**From:** <Joseph\_Hegner@dom.com>  
**To:** <bxs2@nrc.gov>  
**Date:** Tue, Aug 2, 2005 4:40 PM  
**Subject:** Follow-up from July 26, 2005 Conference Call

## Responses to NRC Questions of July 26, 2005 Conference Call

On July 26, 2005, a conference call was held between the NRC Staff and Dominion to discuss Dominion's July 25, 2005 letter, Serial No. 05-457 (Reference 1). During the conference call, the NRC asked several questions on the site-specific analysis that was performed to confirm the appropriateness of the V/H ratios used in the ESP Site Safety Analysis Report (SSAR) to establish the vertical safe shutdown earthquake (SSE) spectrum for the Zone III-IV hypothetical rock outcrop control point. Responses to the NRC's questions are provided on the following pages.

**Figure 1. Poisson's ratio models with upper and lower bound constraints for Model 2.**

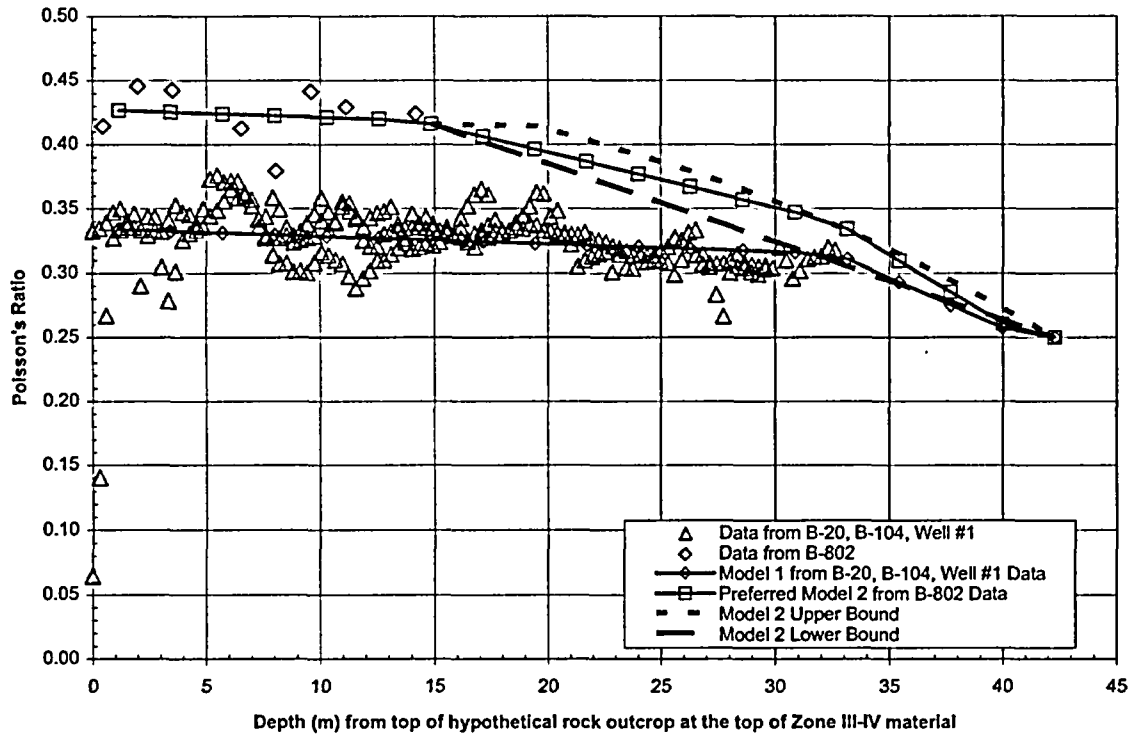
How were Poisson's ratios for Model 2 developed for depths greater than 15m?

Model 2 comprises three linear segments. The first segment [from 0 to ~15m] is the result of a least-squares fit to the available Poisson's ratio data from boring B-802. No S-wave data are available for this boring at greater depths. The end of the deepest [third] segment is constrained to have a Poisson's ratio of 0.25, appropriate for rock at the top of the Mid-Continent crust [EPRI (1993), Reference 2].

The second and third segments of Model 2 are defined to give a simple Poisson's ratio model bounded by two constraints: 1) the model should not cross the Model 1 representation of Poisson's ratio [as a simple two-segment model would], and 2) the corresponding P-wave velocity should not significantly exceed a value of 4,900 m/sec [the P-wave velocity of the rock at the top of the Mid-Continent crust] for depths shallower than 41.0 meters.

If Model 2 had been defined by a single straight line segment from the end of the fit to available data at 15m to the Poisson's ratio value of 0.25 at 41m depth this model would have intersected, and at places, dropped below Model 1. Defined in this manner, Models 1 and 2 would have differed negligibly from depths of ~30m to 41m. Because it was of interest to consider the full range of epistemic uncertainty in the development of the V/H ratios, this convergence of Models 1 and 2 was assessed to be undesirable, establishing a lower bound for the Poisson's ratios of Model 2.

An upper bound to Poisson's ratio Model 2 was defined by the values of Poisson's ratio resulting from fixing the P-wave velocity to have a constant value of 4,900 m/s near the end of the B-802 data at ~15m to the depth of 41m. A

shallower slope model of Poisson's ratio would then imply P-wave velocities greater within the rock column than at its bottom.

Figure 1 shows Model 2 Poisson's ratios and the upper and lower bounding constraints specified.

Figure 2. Preferred V/H mean and fractiles ratios, using weights of 0.25 and 0.75 for Poisson's ratio Models 1 and 2.

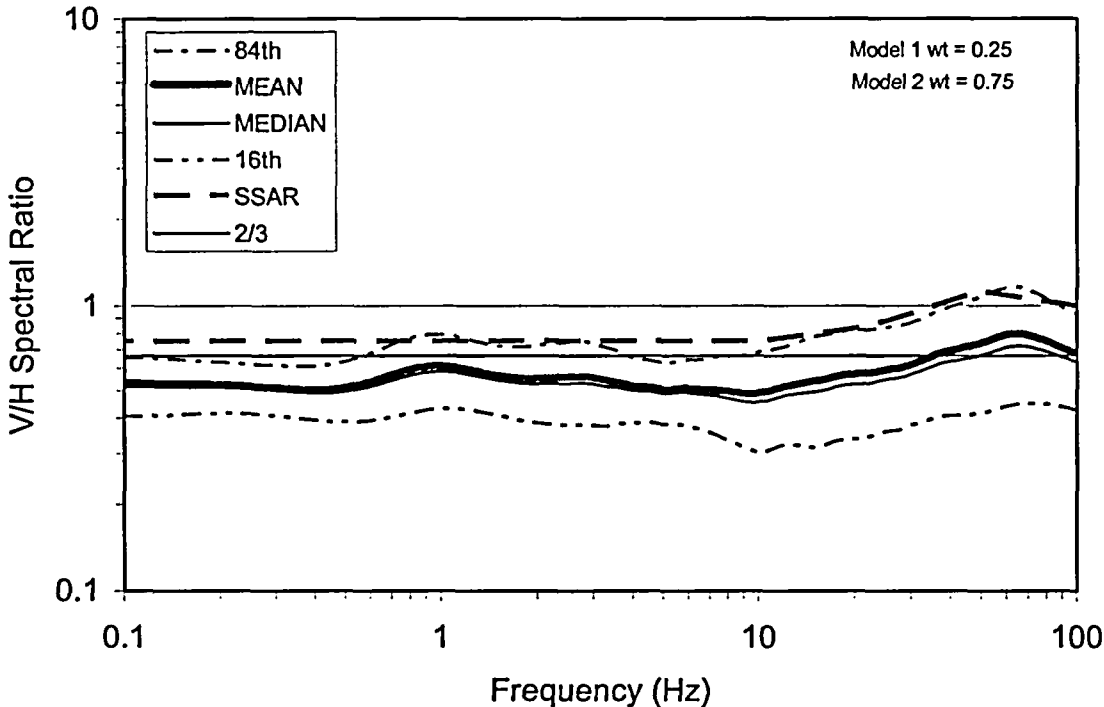
What are the effects on the resultant V/H ratios of considering different weights between Model 1 and Model 2?

Figure 2 shows the resulting V/H ratios for the mean and various fractile results where the weights of 0.25 and 0.75 have been considered for P-wave Models 1 and 2, respectively. A graphical measure of the sensitivity of V/H ratios to the weights assigned to Poisson's ratio Models 1 and 2 is provided in several additional plots. In Figure 3, Model 1 has been given a weight of 1.0 and Model 2 a weight of 0.0, putting complete confidence in the older, original site geotechnical investigation data. In Figure 4, Model 2 has been given a weight of 1.0 and Model 1 a weight of 0.0, putting complete confidence in the recent ESP subsurface investigation data. Finally, both models have been given equal weight in Figure 5.

While the 0.25 Model 1 and 0.75 Model 2 weight distribution is preferred, the effect on V/H ratios is modest over the entire range of possibility and does not affect the fundamental conclusion that the V/H ratios given in NUREG/CR-6728 for hard rock and used in SSAR Table 2.5-27A for development of the vertical SSE spectrum are appropriate.
